How consultation feedback shaped the revised Scout Moor II proposals.

How consultation shaped Scout Moor II

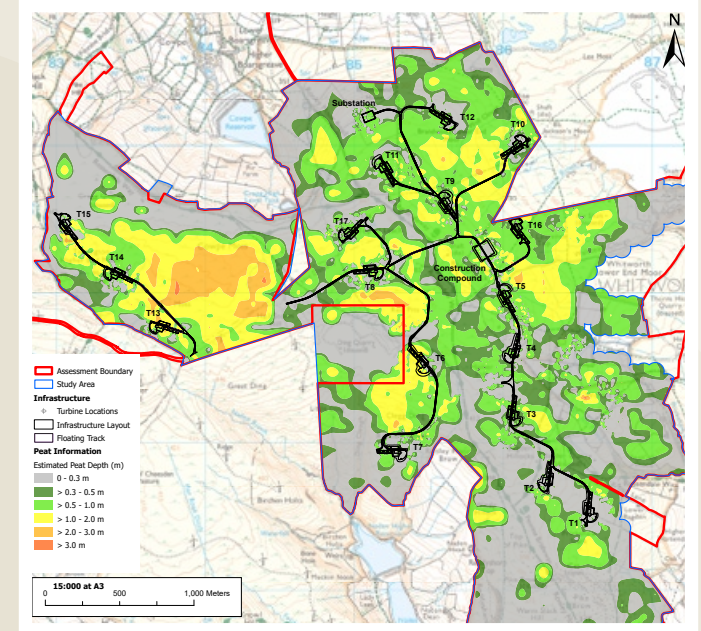
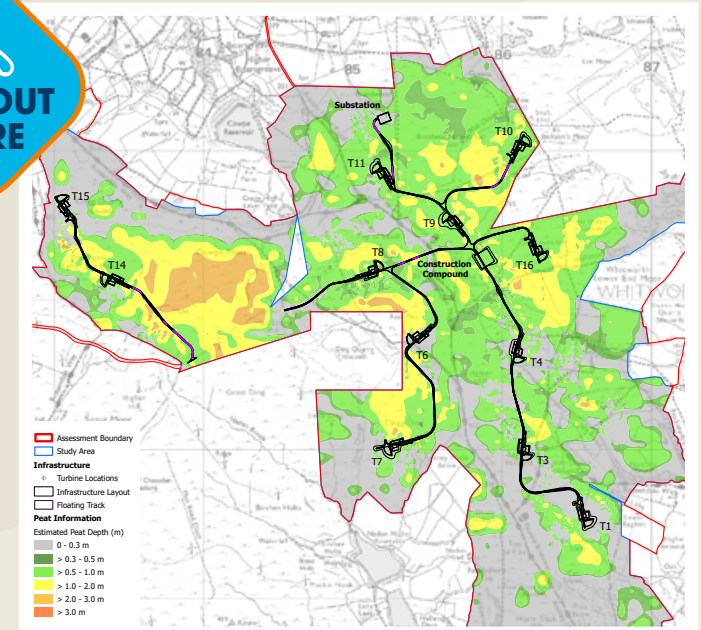
- Concerns were raised about potential impacts on deep peat, carbon release and long-term peatland protection.

- Reduced the overall project footprint.
- Removed turbines T5 and T13 from the deepest peat areas, and repositioned turbines T3, T6, T7 and T9, along with the on-site substation, to reduce impacts on peatland.
- Increased the proportion of infrastructure located on areas of less than 30cm of peat, avoiding areas of deeper peat in accordance with Natural England guidance.
- Reduced peat excavation volumes by 28%.

- The deepest peat areas have been protected.
- Substation location revised to reduce peat impacts.
- Reduced peat excavation volumes by 28%.

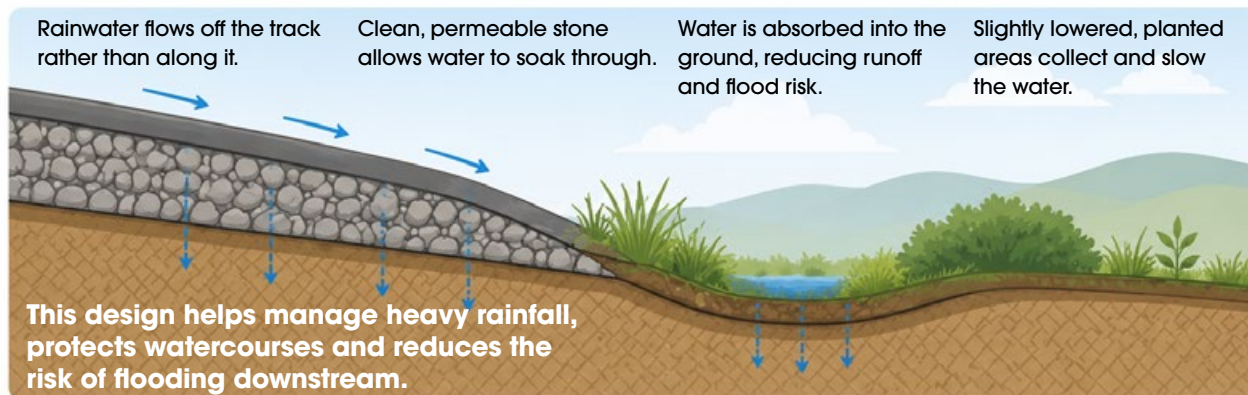
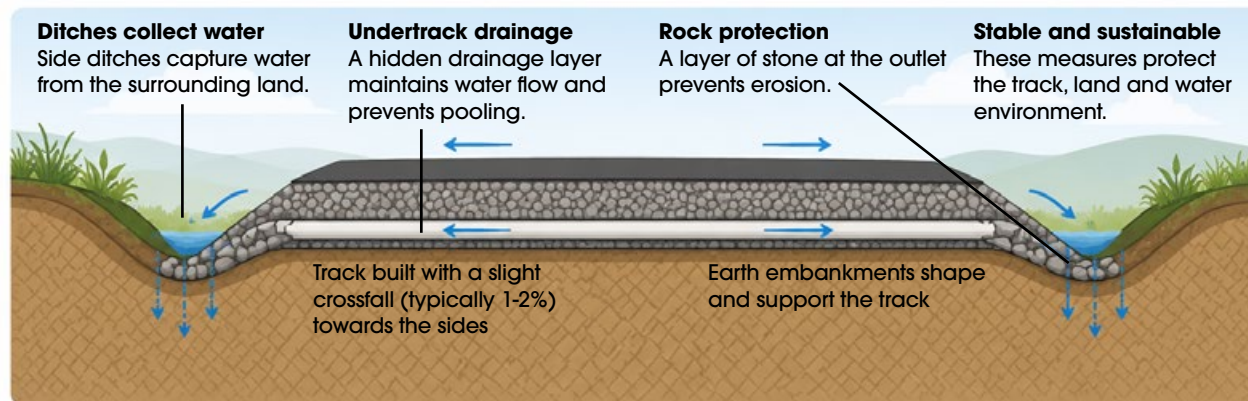
- Residents raised concerns that construction on the moor could increase surface water runoff and potentially worsen flooding in surrounding communities.

- Attenuation ponds, swales and drainage features have been included across the site to slow and temporarily store rainfall.
- Existing drainage catchments and flow routes have been maintained.
- Drainage has been designed to accommodate future climate change and more intense rainfall.
- Comprehensive peatland restoration will help the landscape retain water naturally.

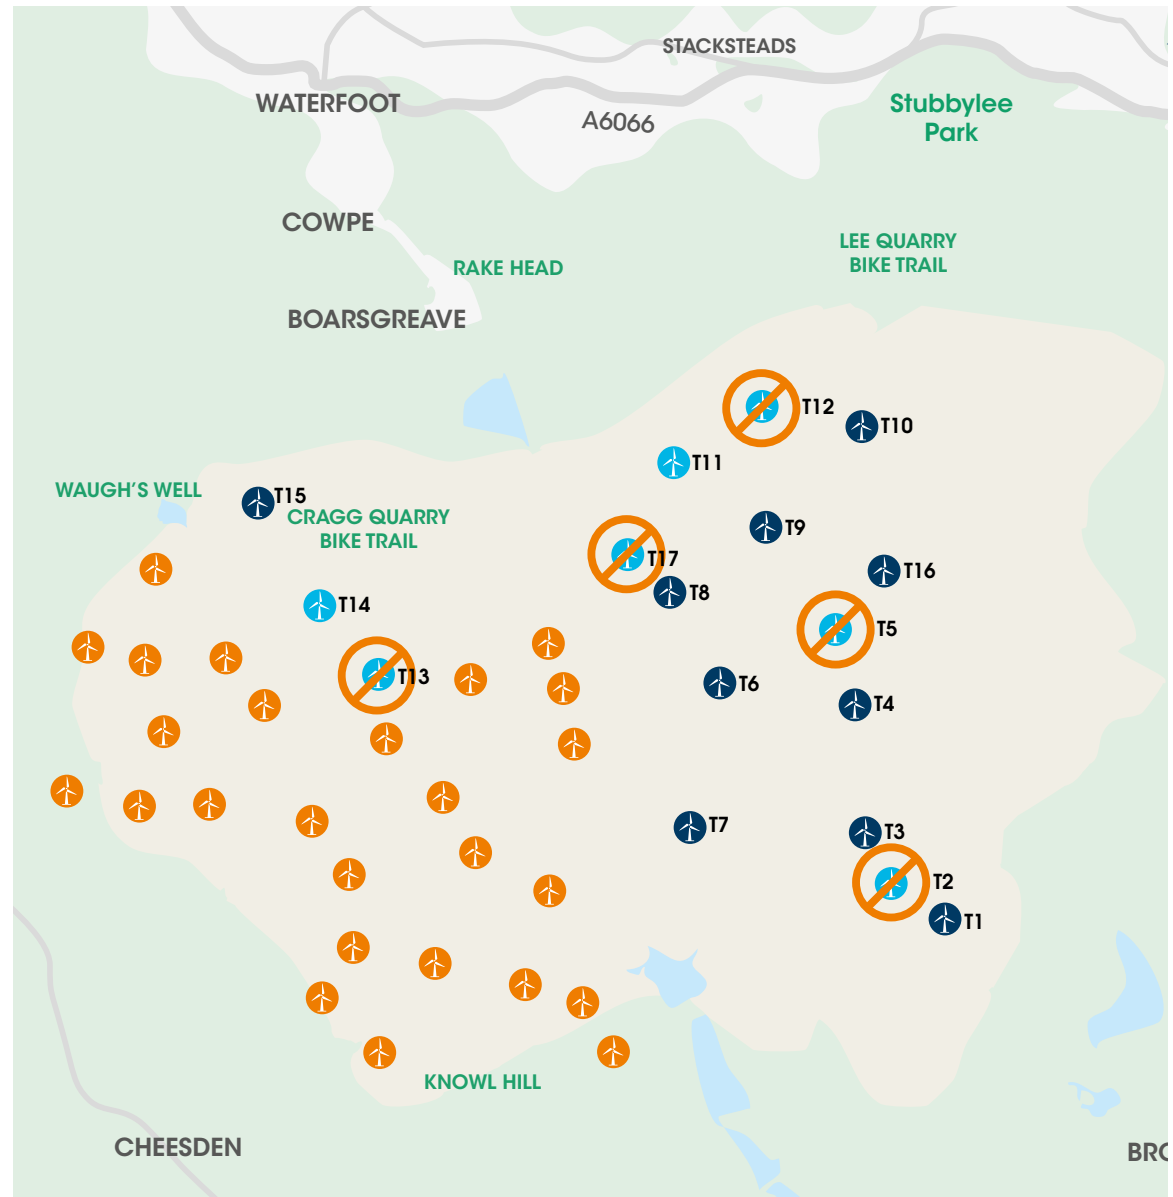
- Concerns about potential skyline effects and cumulative visibility

- The revised layout removes turbines from the most sensitive viewpoints and improves spacing between the remaining turbines.
- T12 and T17 removed to reduce visual effects from the north.
- T2 and T5 removed to reduce visual effects from the east and south-east.
- Wider turbine spacing reduces visual clustering and creates a simpler, more balanced layout.

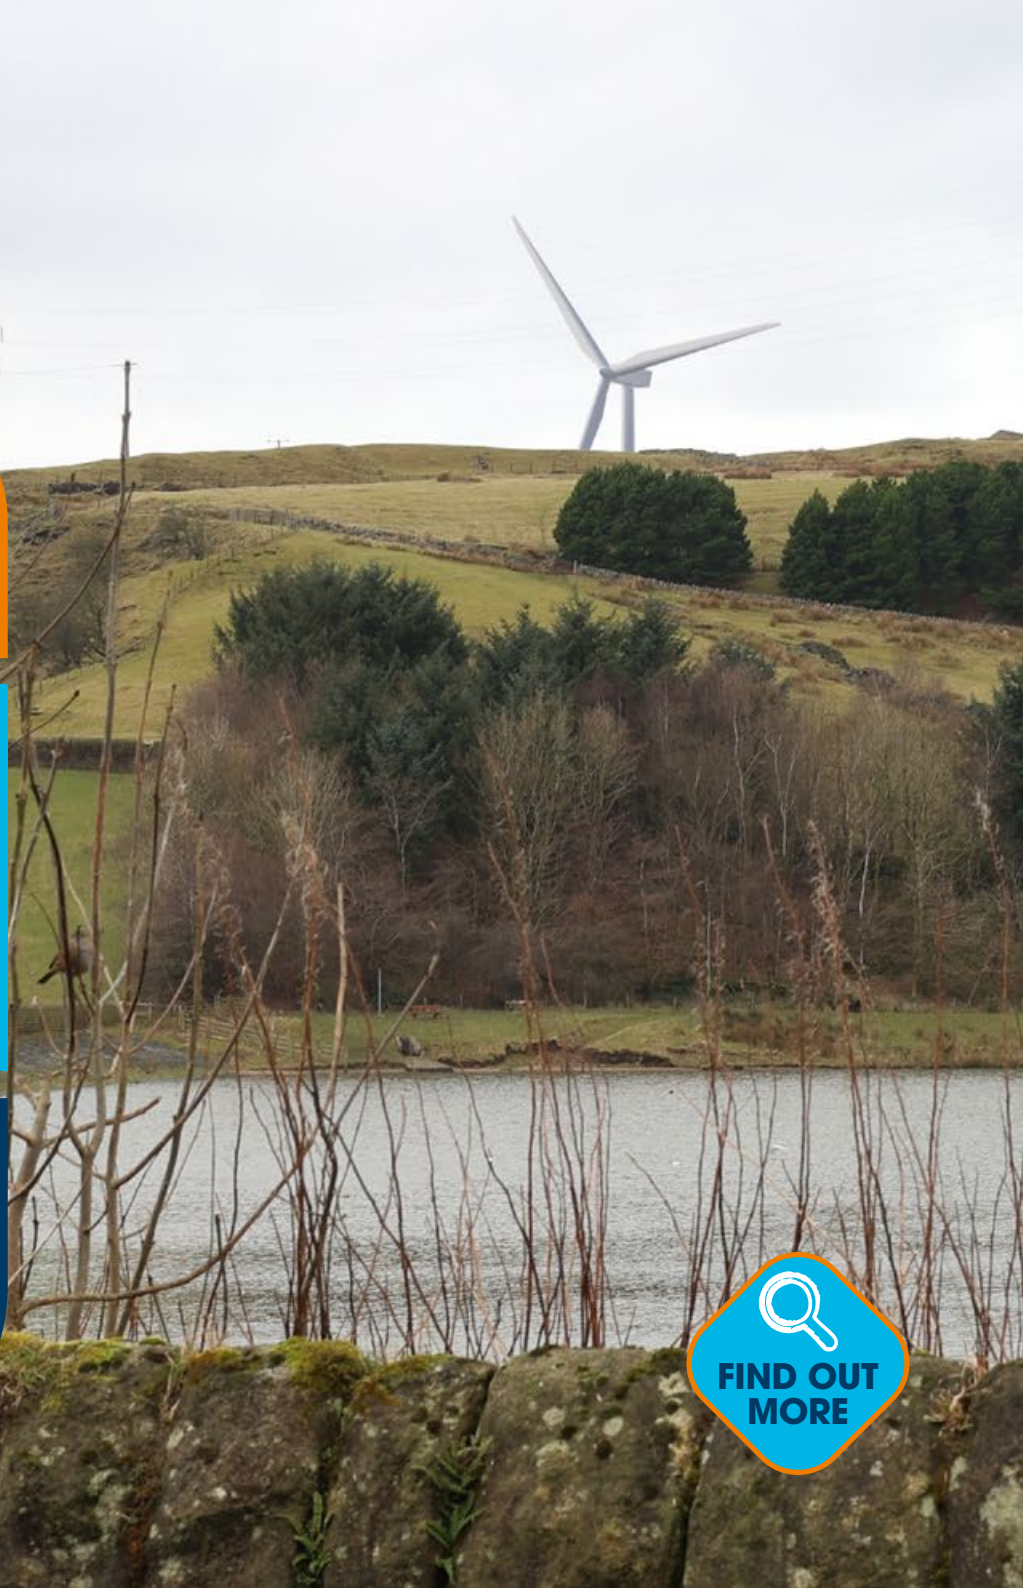
- Residents and recreational users raised concerns about potential impacts on access to the moor, including the experience of walkers, horse riders and users of key routes.

- Removed T17 to increase separation from the Pennine Bridleway and Mary Towneley Loop
- Refined the layout to reduce turbine presence around Rooley Moor Road
- Reduced the number of turbines adjacent to Rooley Moor Road from 11 to 8

- Turbines within 200m of the Pennine Bridleway reduced from 11 to 8
- Greater separation from Rooley Moor Road
- Improved openness across key recreational areas

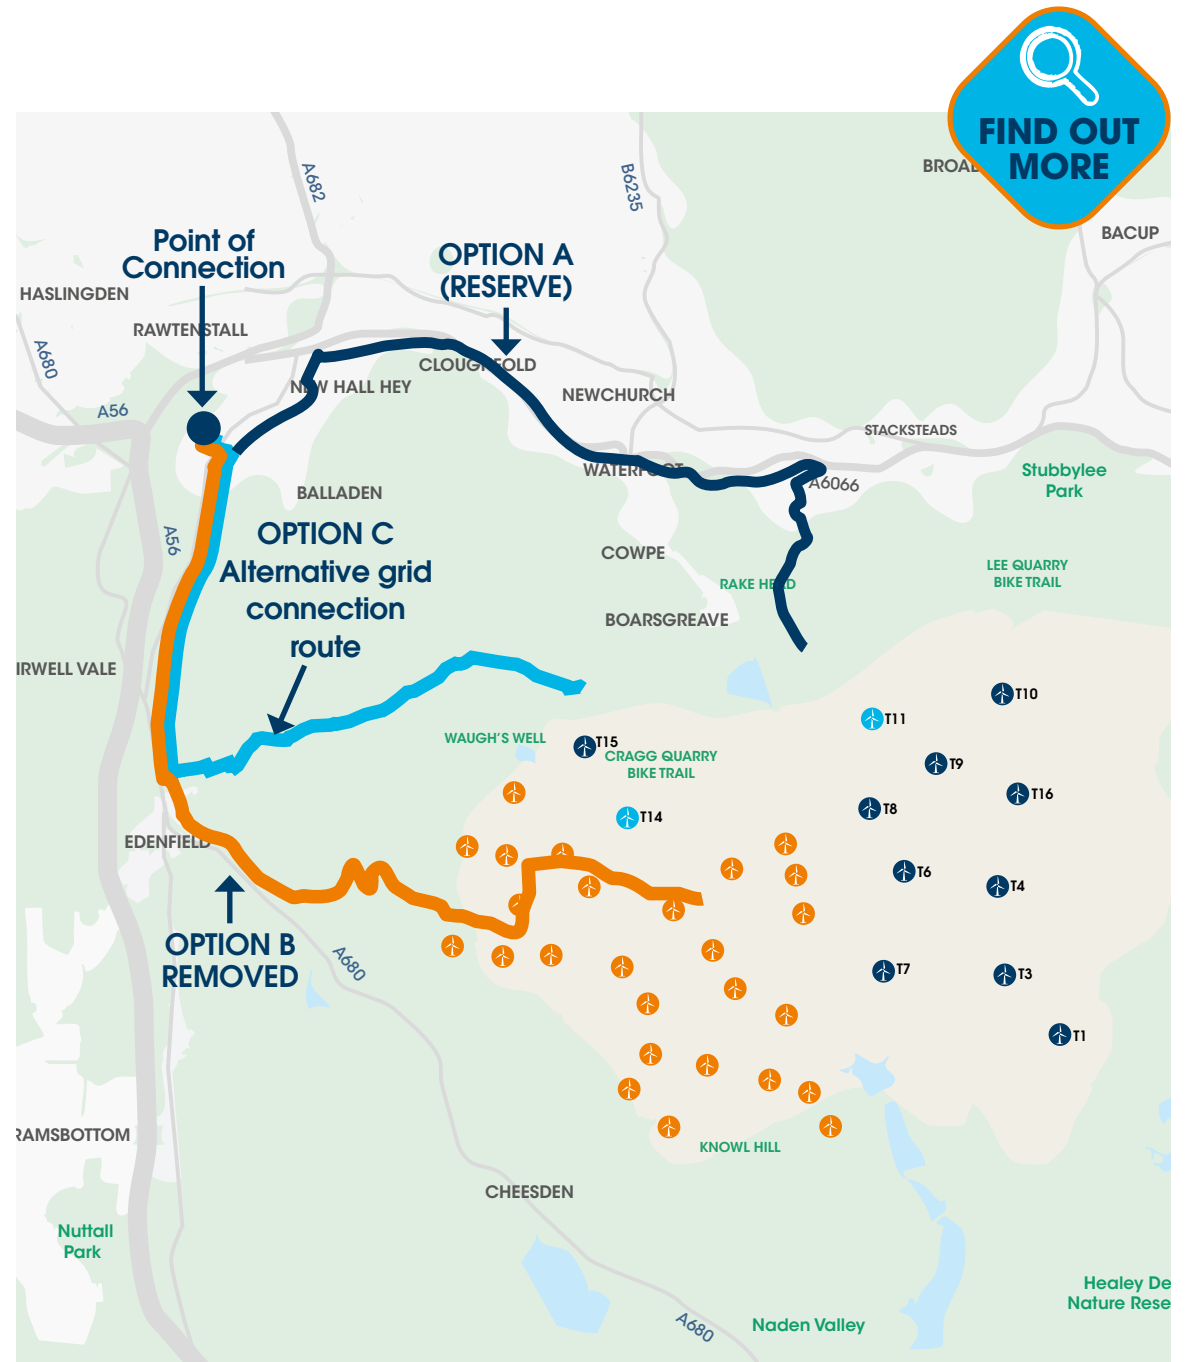
- Concerns focused on potential construction traffic effects and community disruption, particularly in Edenfield and Waterfoot.

- Removed grid connection route (Option B) through Edenfield village
- Introduced alternative grid connection route (Option C) that reduces the amount of disruption on the public highway

- Reduced disruption through Edenfield Village
- Reduced construction traffic and HGV movements
- Reduced disruption on local roads and nearby communities
